Rachel Hodge - Montifiere Application

APPLICATION NO. MP09_0188 and MP10_0044 _ EXPANSION OF THE EXISTING AGED CARE FACILITY AT SIR MOSES MONTEFIORE JEWISH HOME, 100-120 KING STREET AND 30-36 DANGAR STREET, RANDWICK.

Below are extracts from the application showing the discrepancy between the concept plan (left) showing the proposed building footprint of Building F (outlined in red) and the Landscape Plan (right) where the play area is included as landscaped area (hatched in orange).

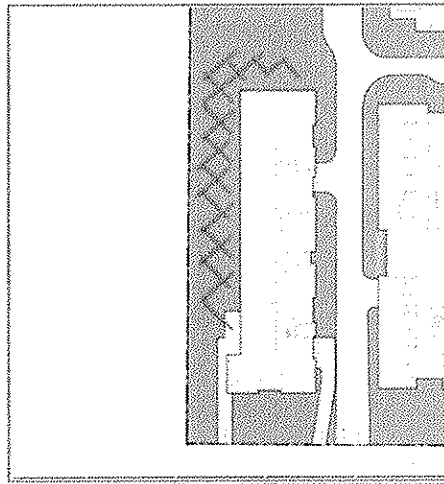
The childcare centre's play area is proposed to be located in the setback to Centennial apartments yet has been included in the landscape ratio. The area should not be included in the calculation of LSR and should be set aside for deep root planting. Further, the setback should be increased in this location and fully planted with deep root planting to accommodate the increase height / bulk / scale of this building.

Landscaping is insufficient in the setback and inaccurate for the purpose of calculating landscape ratio. Landscaping should be extended to shield neighbours from the extent of the commercial operations intended.

Photomontage 1 - View from corner of Bangor Street & King Street looking West along King Street

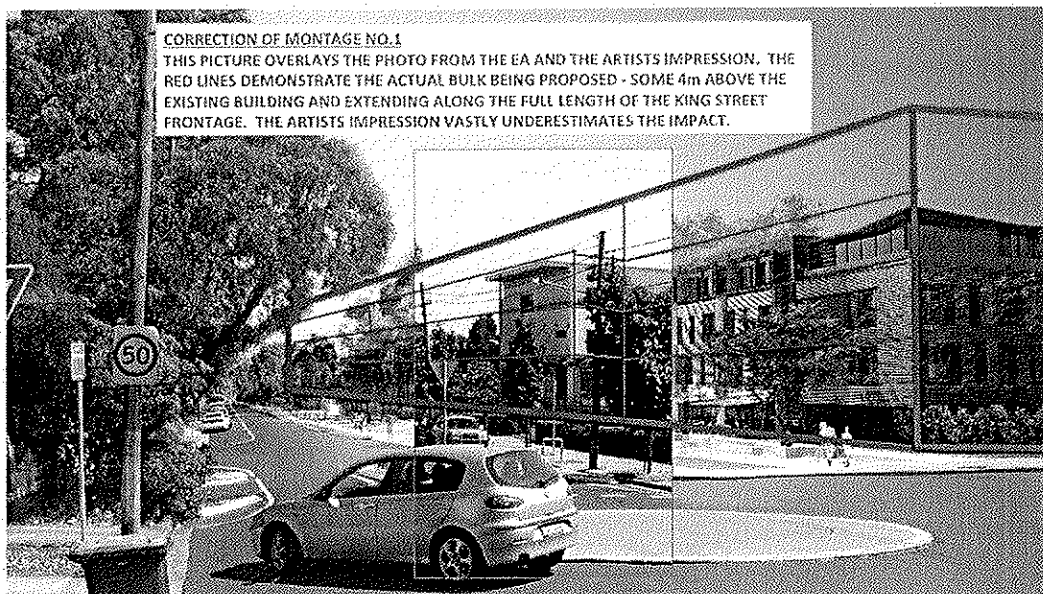
Although artist impressions / contextual studies are included in the application, they appear to be inaccurate in terms of the scale of the buildings and do not show the relationship of the building to the residential buildings which dominate surrounding streets

The below is a revised rendition of the likely bulk and scale of the buildings on King St (noting that the base pictures are photo montages taken from the application). As can be seen, a substantial underestimation of the bulk and scale without even showing the context of these buildings to surrounding residential dwellings.

CORRECTION OF MONTAGE NO. 2

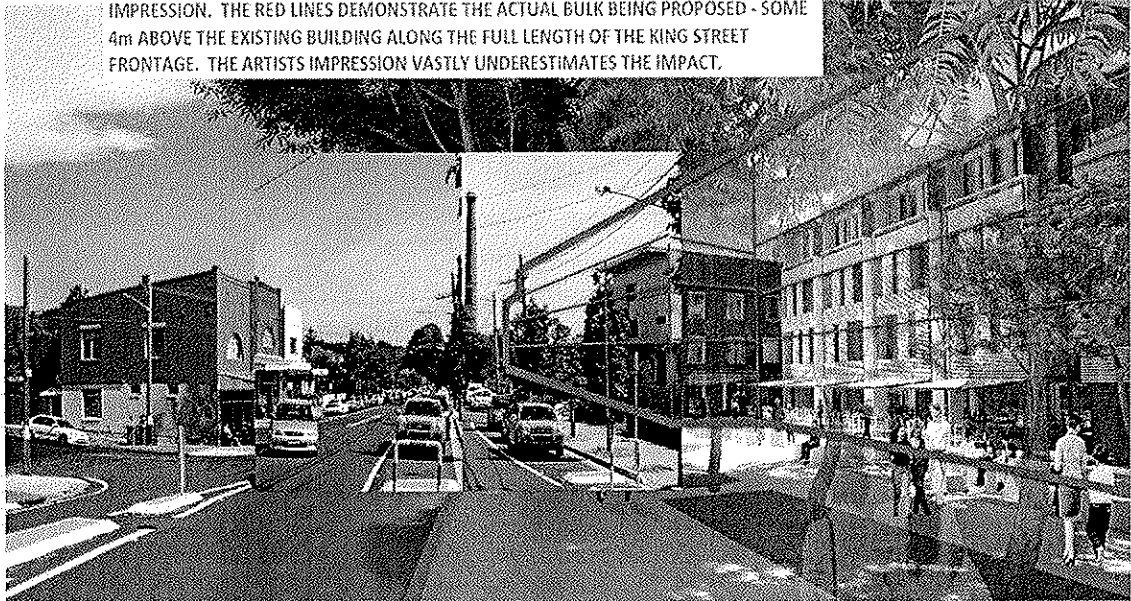
THIS PICTURE TAKES THE PHOTO FROM THE EA AND OVERLAYS IT ON THE ARTISTS IMPRESSION. THE RED LINES DEMONSTRATE THE ACTUAL BULK BEING PROPOSED - SOME 4m ABOVE THE EXISTING BUILDING ALONG THE FULL LENGTH OF THE KING STREET FRONTAGE. THE ARTISTS IMPRESSION VASTLY UNDERESTIMATES THE IMPACT.

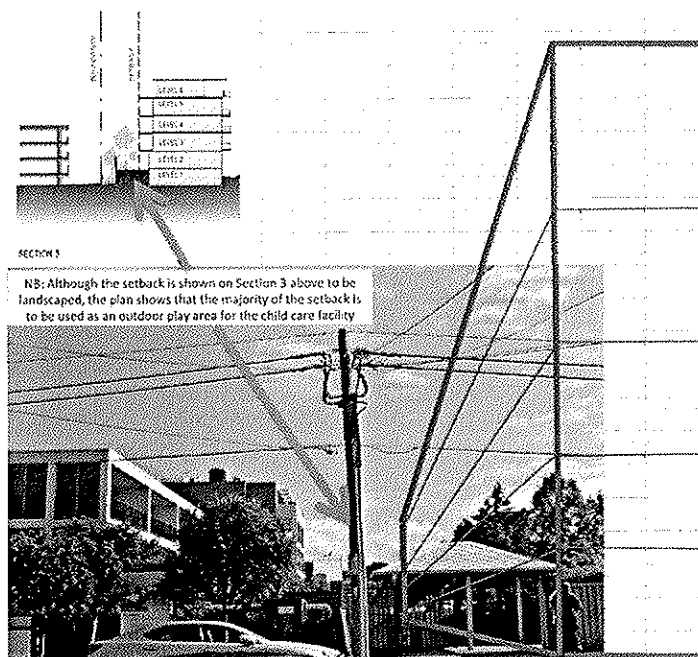
As no contextual studies have been undertaken to show the scale of Building F in relation to the Centennial apartments, below is a representation of how Building F might relate.

Clearly Building F dwarfs the Centennial apartments and is out of keeping with the area.

Montages should be prepared by the applicant to better understand the impacts of this building.
